**Addendum No. 3**

**Final Environmental Impact Report  
for Metro Gold Line Foothill Extension - Azusa  
to Montclair (SCH 2010121069)**

**Evaluating Minor Design Changes of the Project  
Azusa to Montclair**

Metro Gold Line Foothill Extension Construction Authority  
March 2016

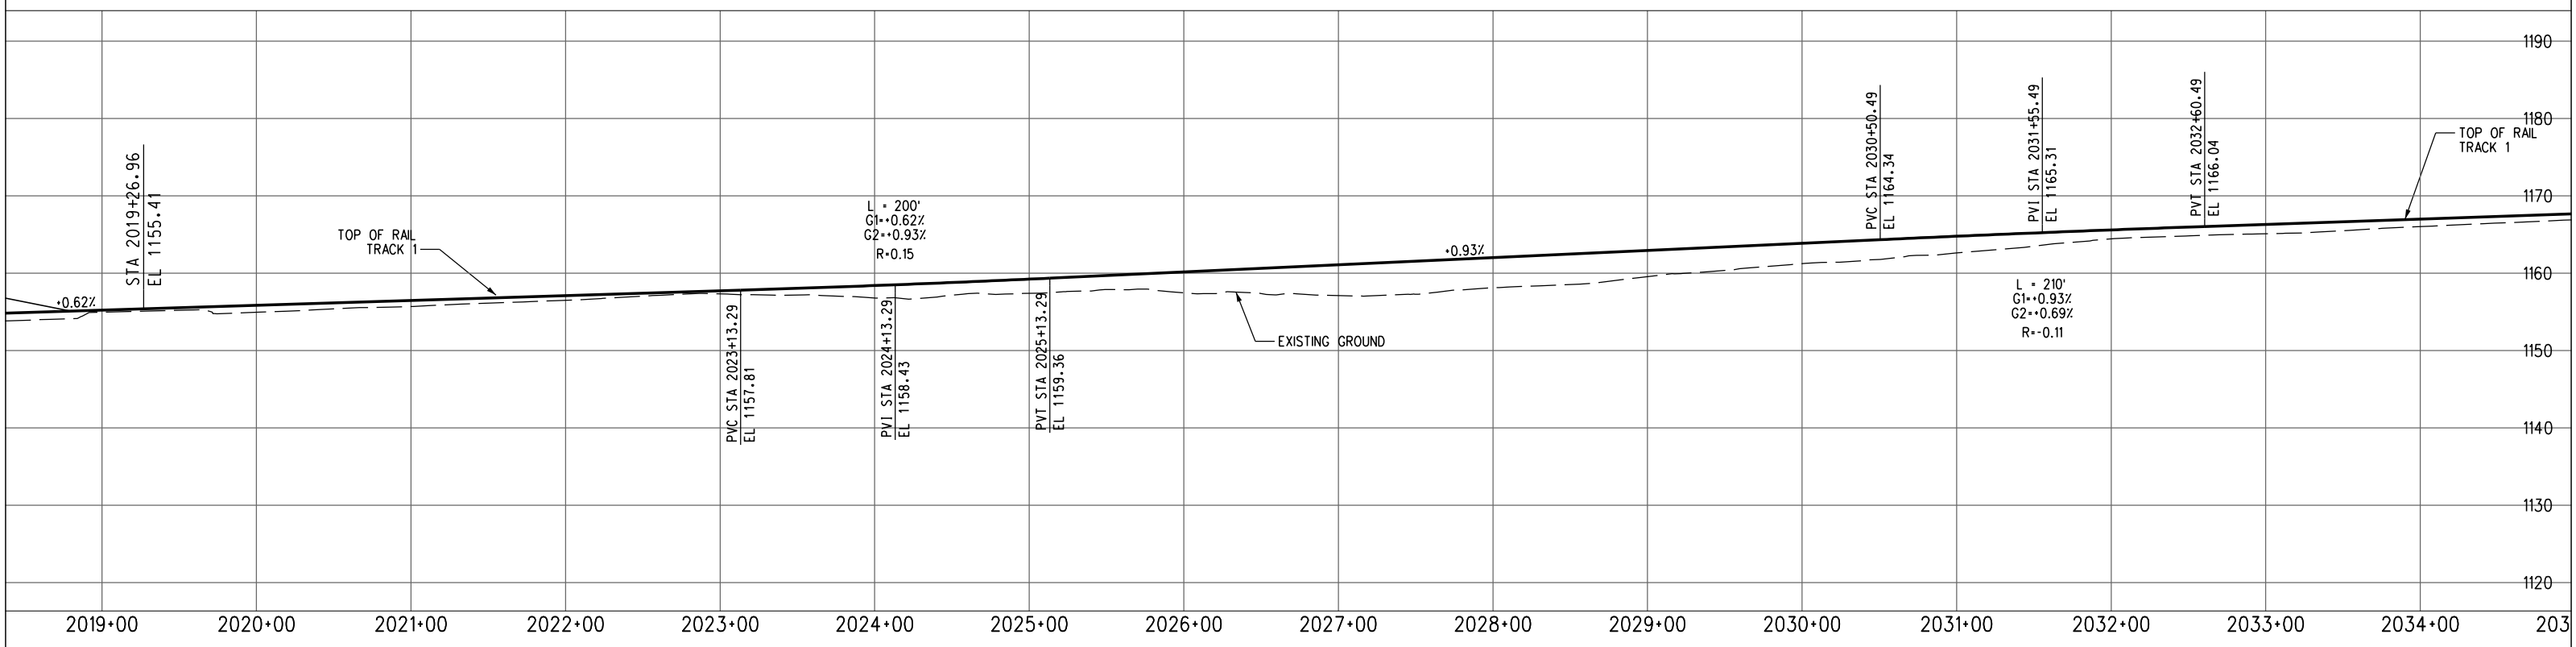
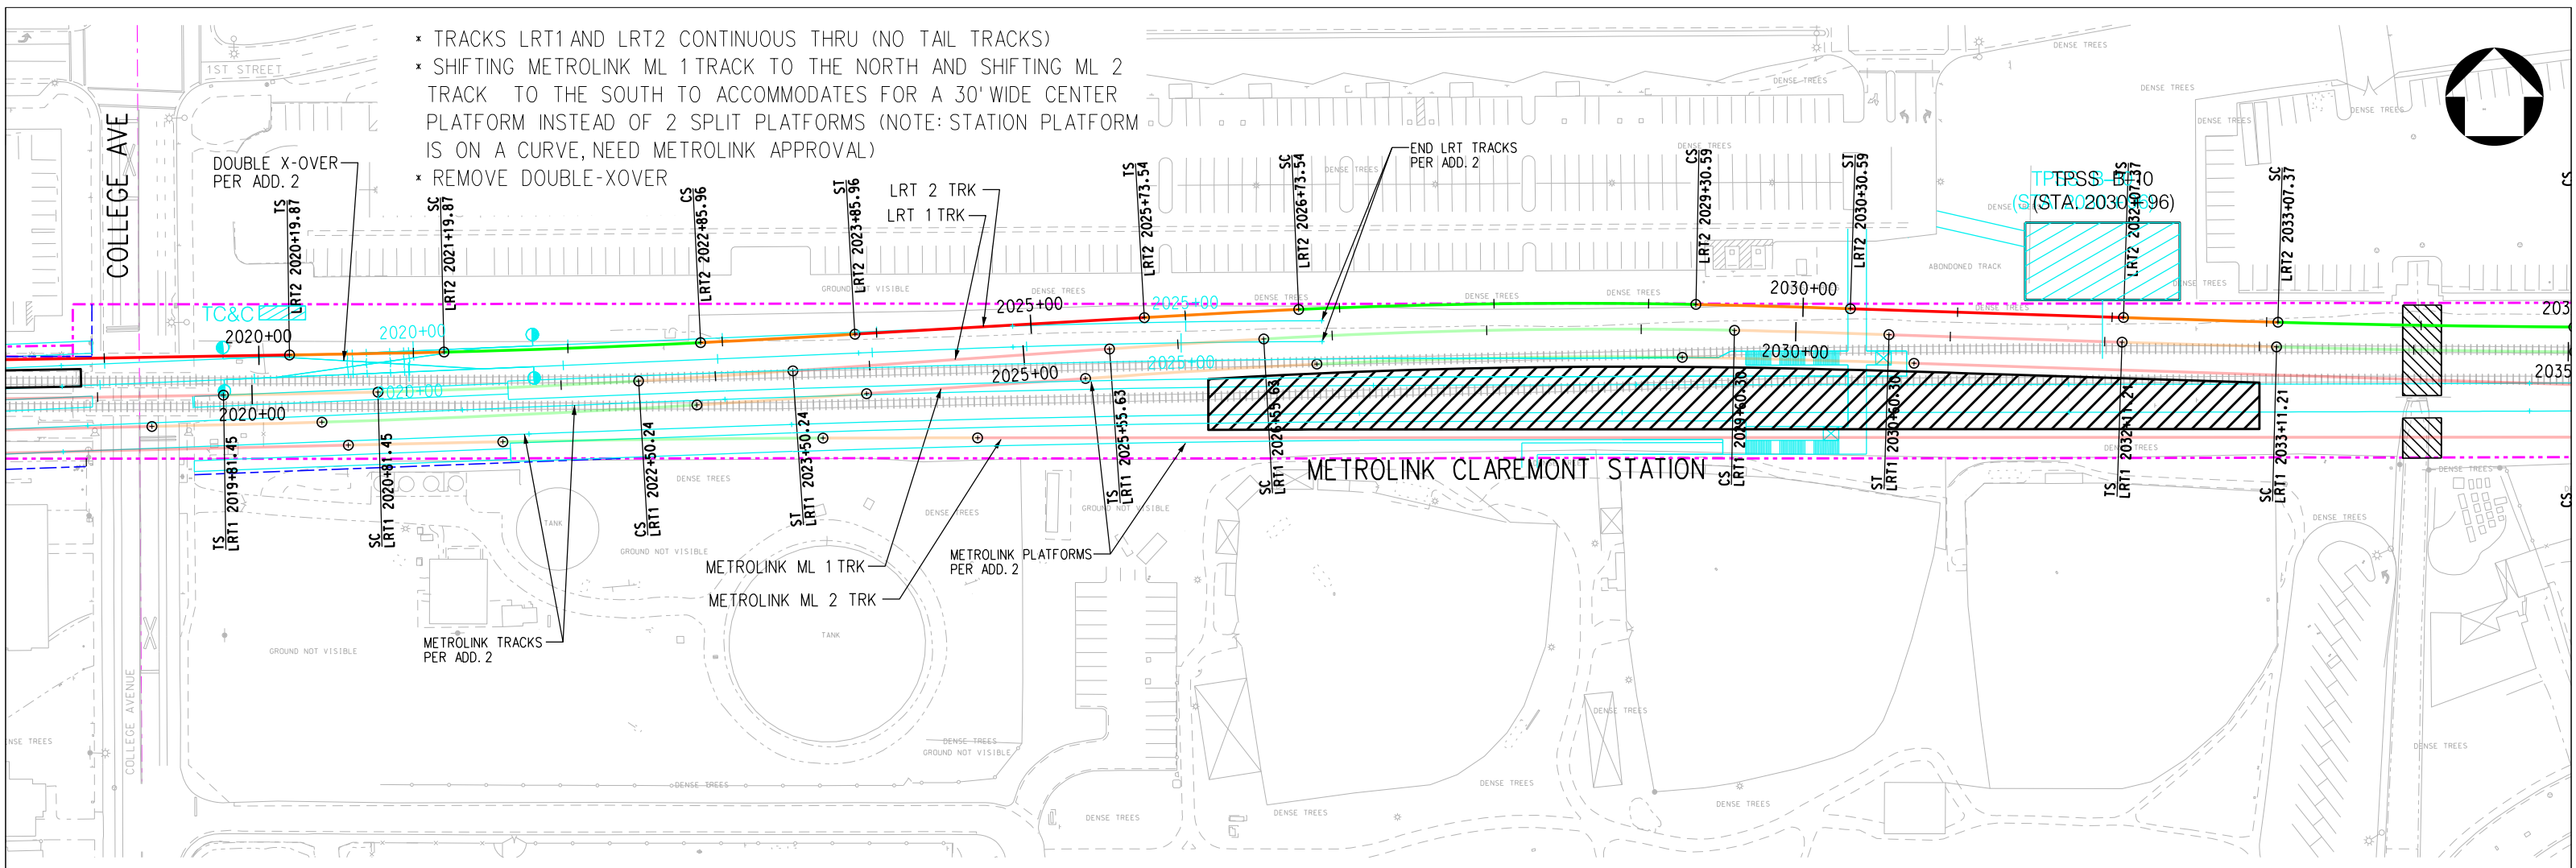
- ✗ TRACKS LRT1 AND LRT2 CONTINUOUS THRU (NO TAIL TRACKS)
- ✗ SHIFTING METROLINK ML 1 TRACK TO THE NORTH AND SHIFTING ML 2 TRACK TO THE SOUTH TO ACCOMMODATES FOR A 30' WIDE CENTER PLATFORM INSTEAD OF 2 SPLIT PLATFORMS (NOTE: STATION PLATFORM IS ON A CURVE, NEED METROLINK APPROVAL)
- ✗ REMOVE DOUBLE-X-OVER

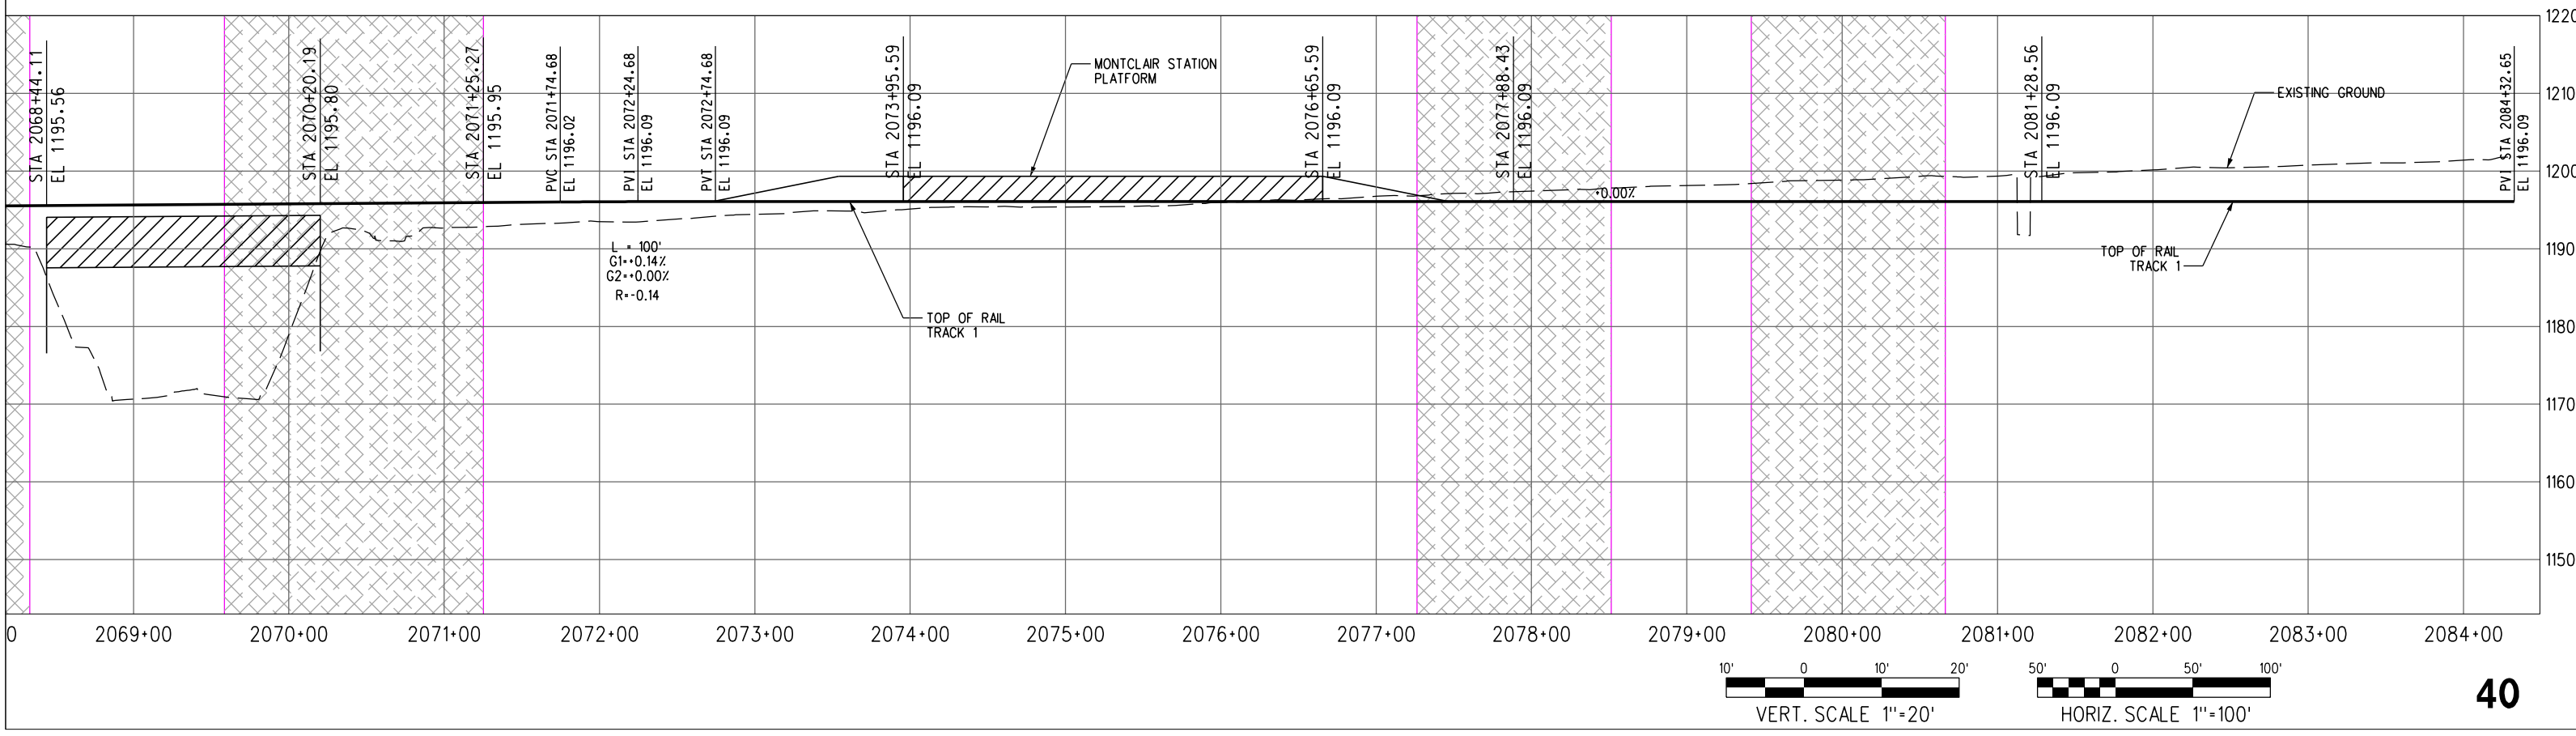
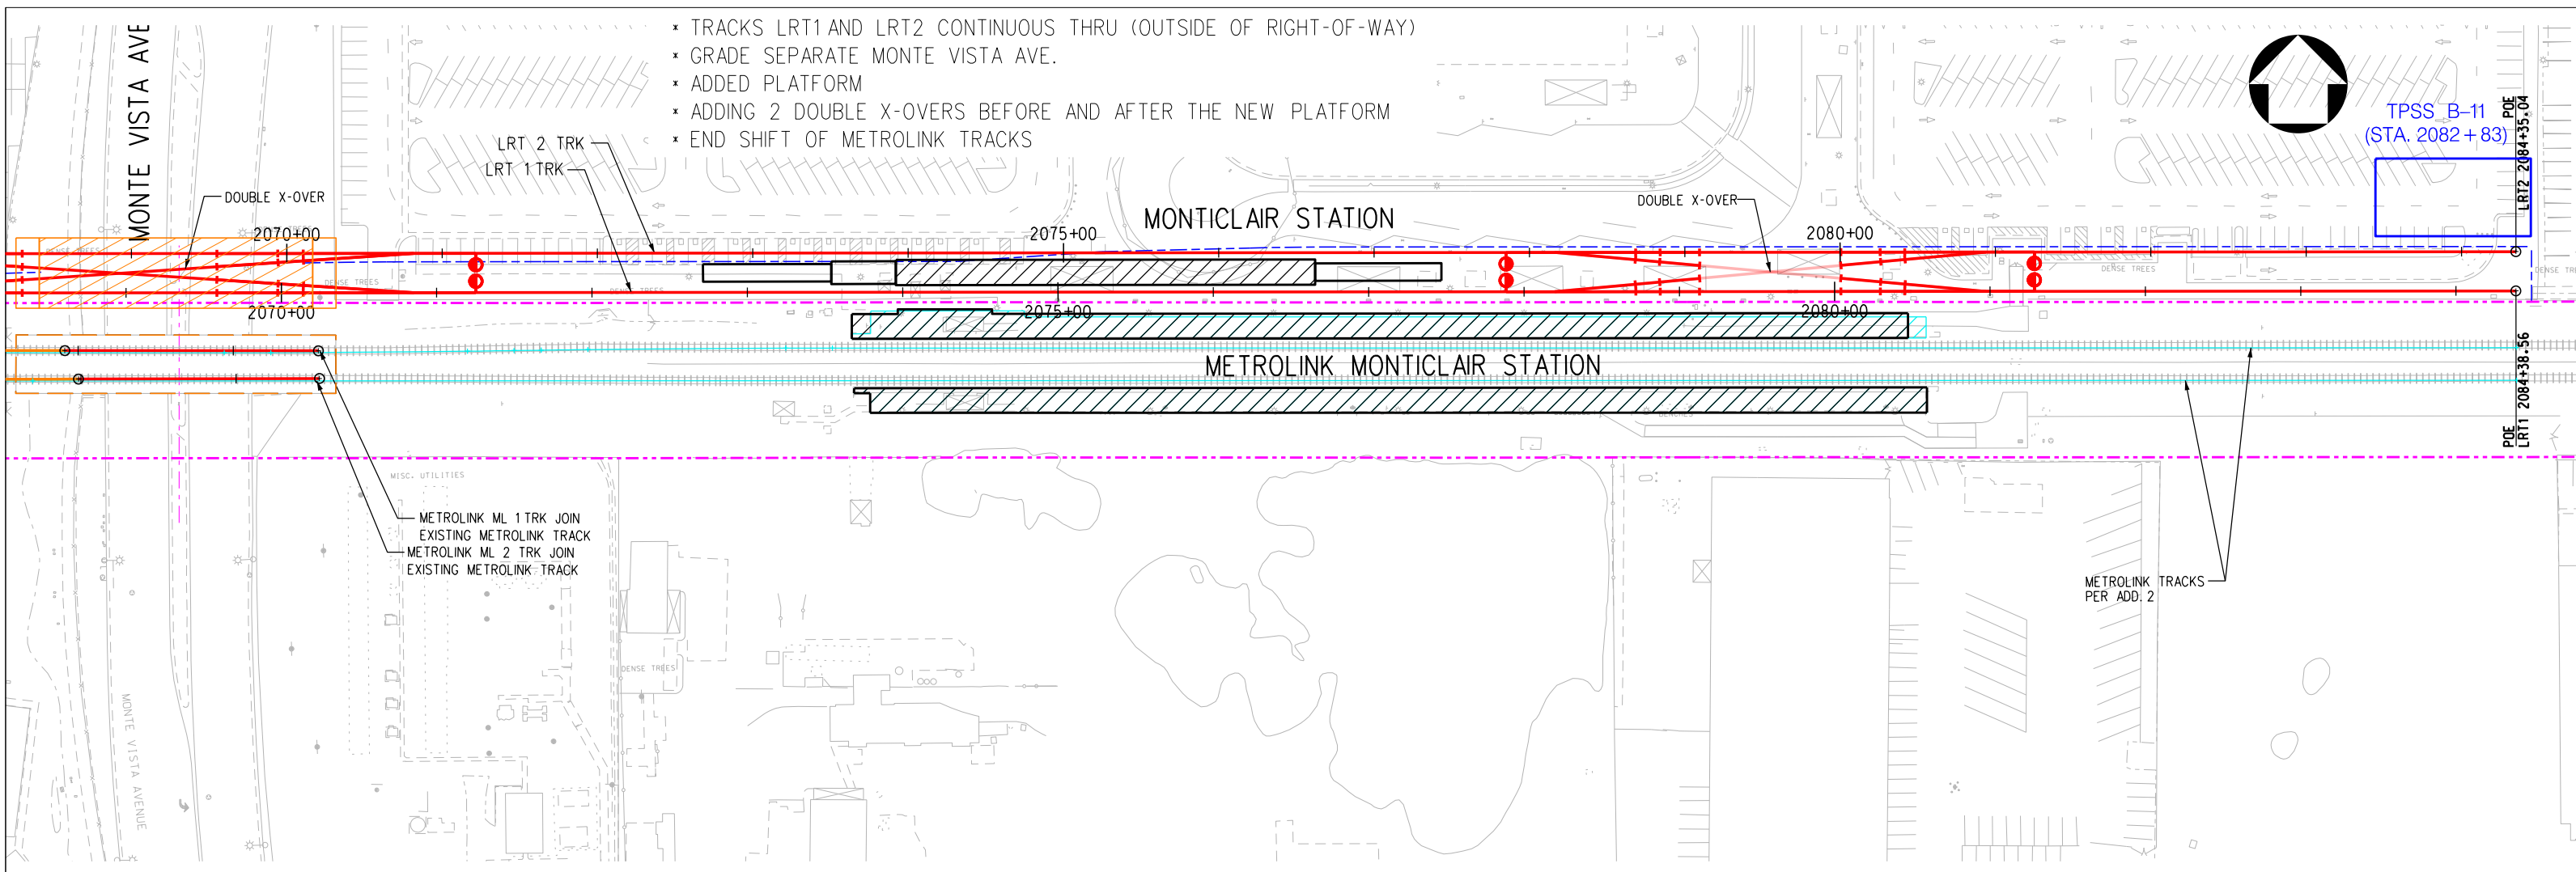
- \* TRACKS LRT1 AND LRT2 CONTINUOUS THRU (OUTSIDE OF RIGHT-OF-WAY)
- \* METROLINK TRACKS SHIFTED SOUTH
